**DATE:** February 13, 2009

## Addendum No. 2

**SUBJECT:** US26: N. Plains – 185th Avenue Section  
Sunset Highway  
Washington County  
Grading, Drainage, Structures, Paving, Signing and Signals Project  
(Bids to be opened and read February 19, 2009)

**CONSTRUCTION NOTES** SHEET NO. 14B

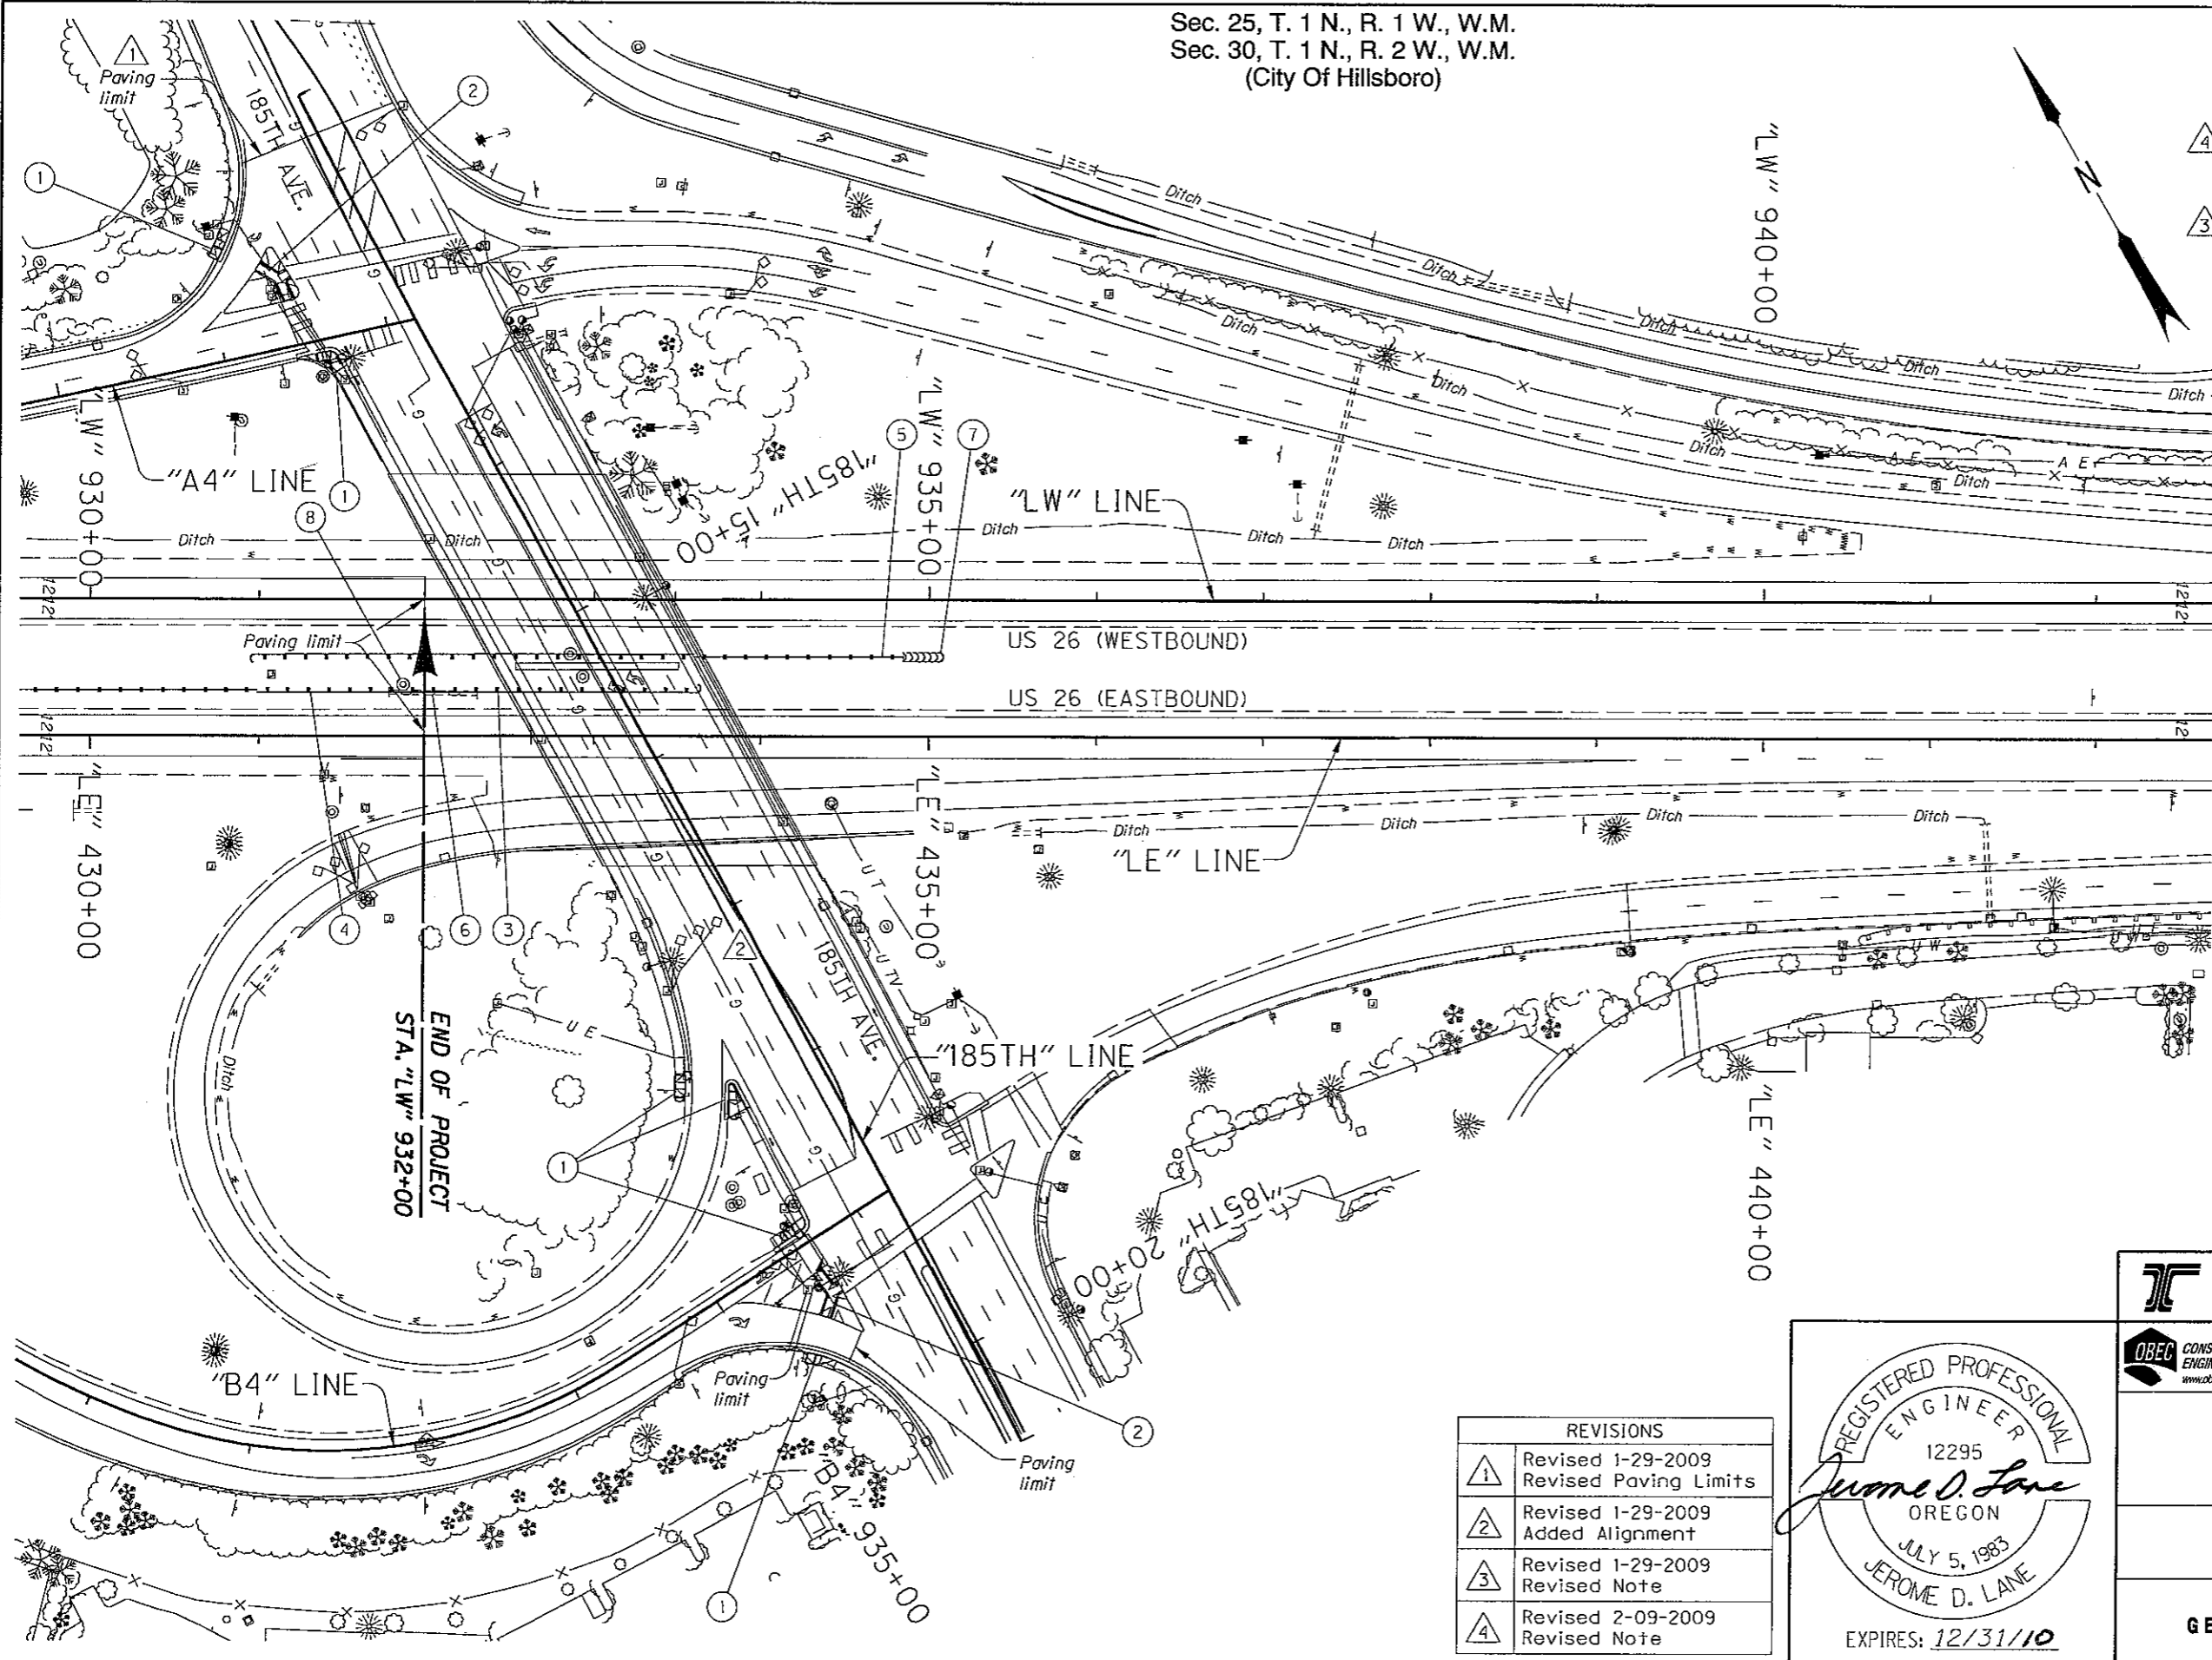
REVISIONS	
①	Revised 1-29-2009 Revised Note
②	Revised 1-29-2009 Added Note
③	Revised 2-09-2009 Revised Note

SHEET NO. **29A**

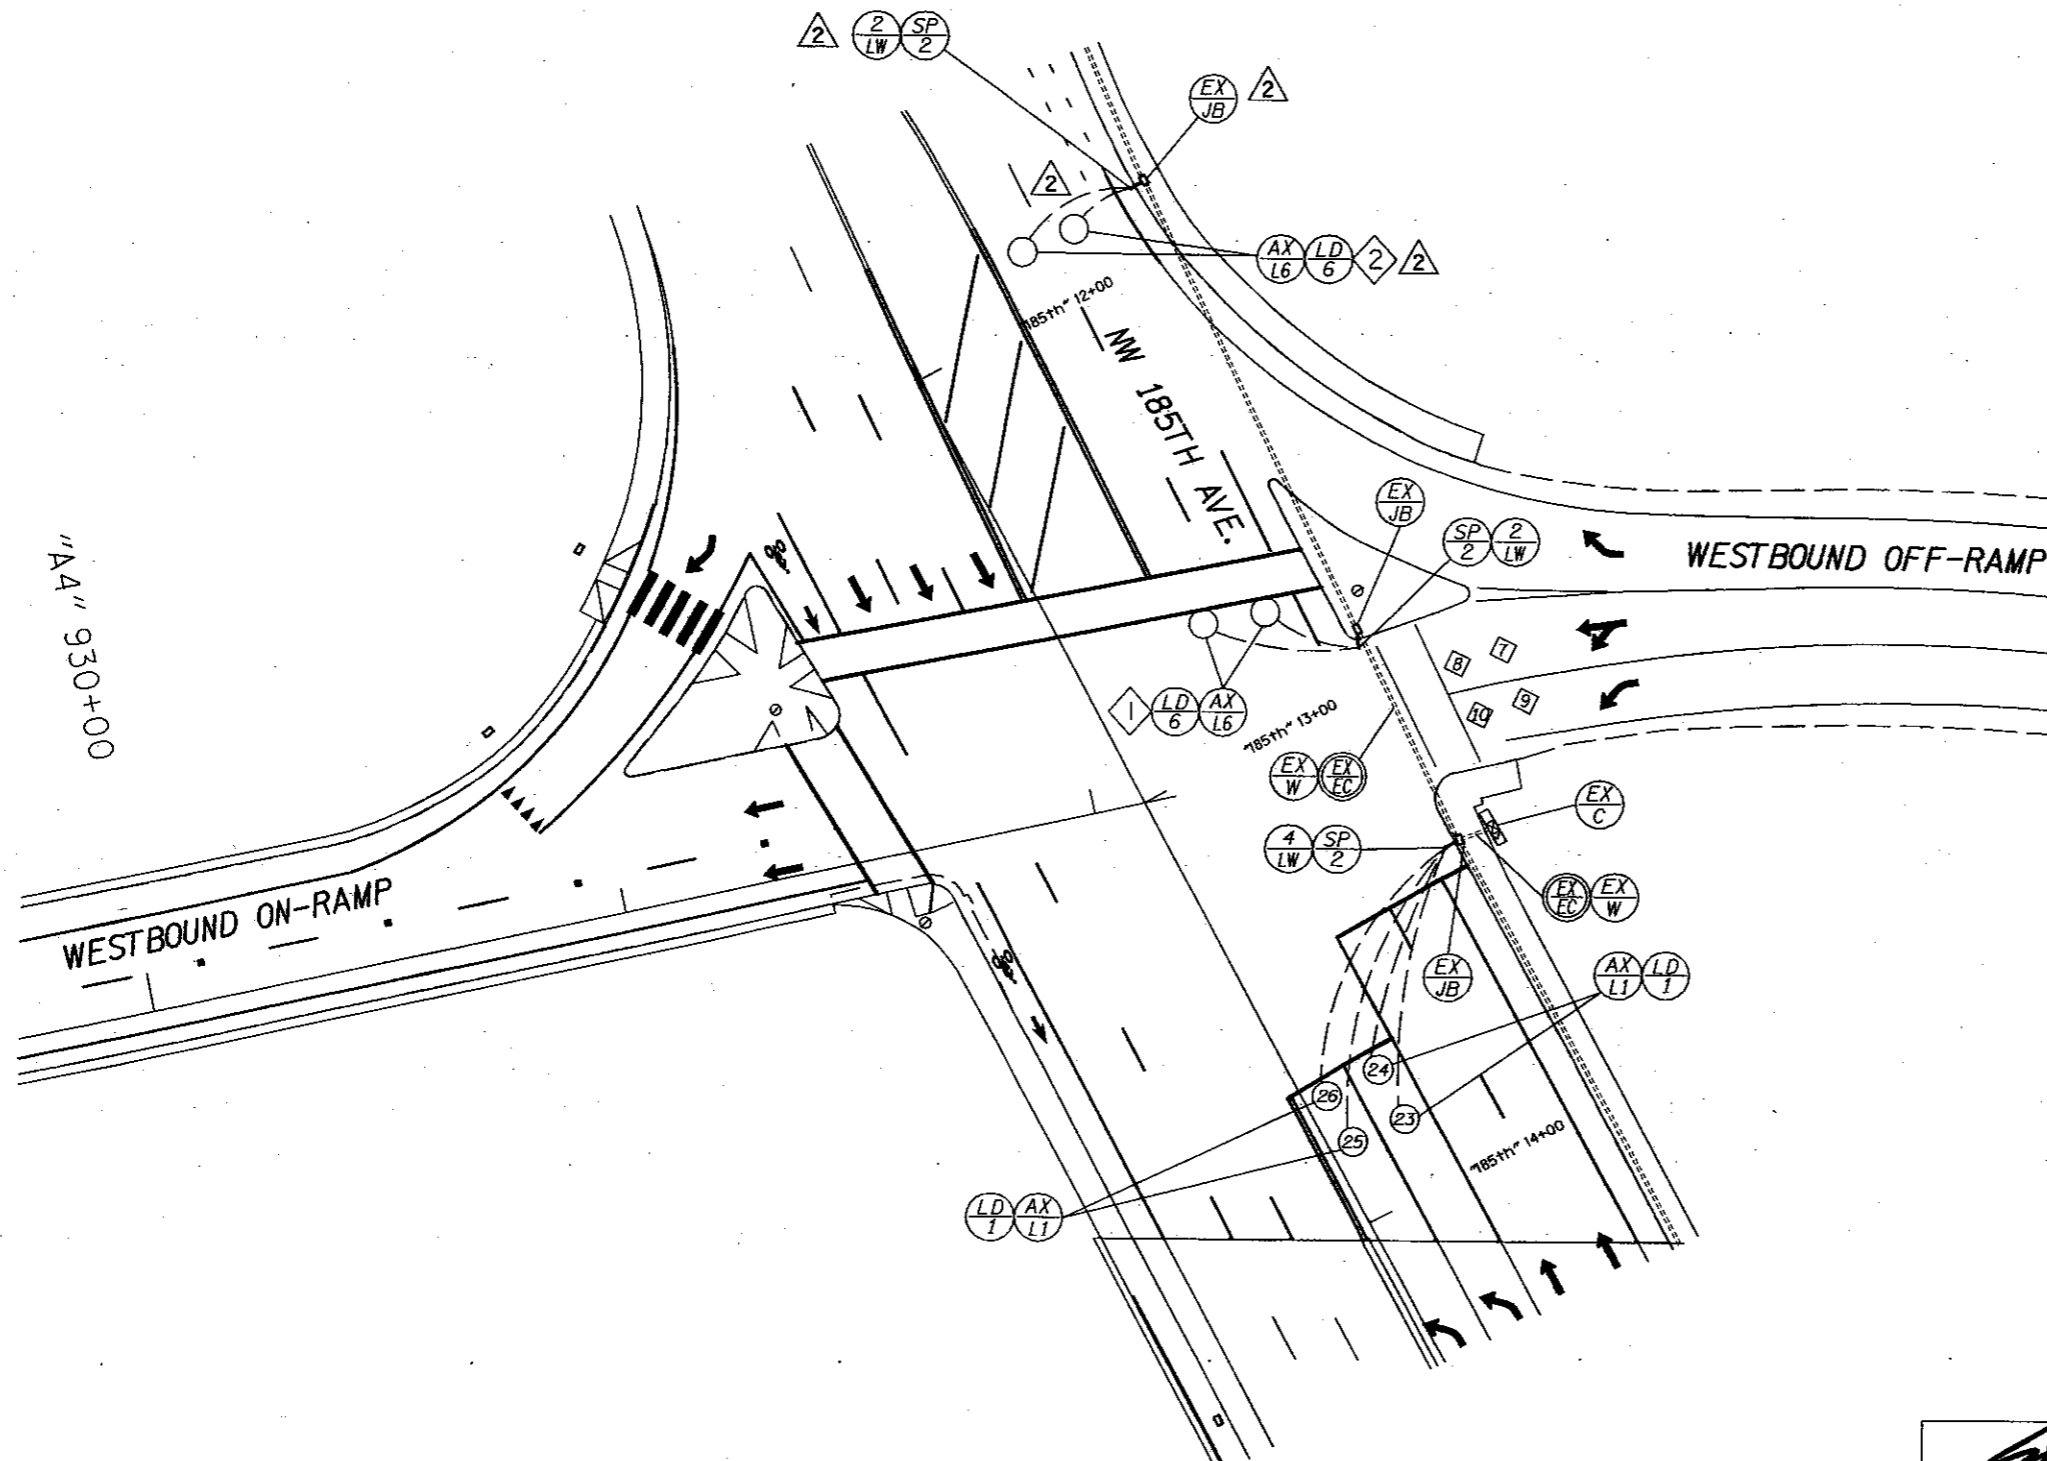
REVISIONS	
①	Revised 1-29-2009 Revised Paving Limits
②	Revised 1-29-2009 Added Alignment
③	Revised 1-29-2009 Revised Note
④	Revised 2-09-2009 Revised Note
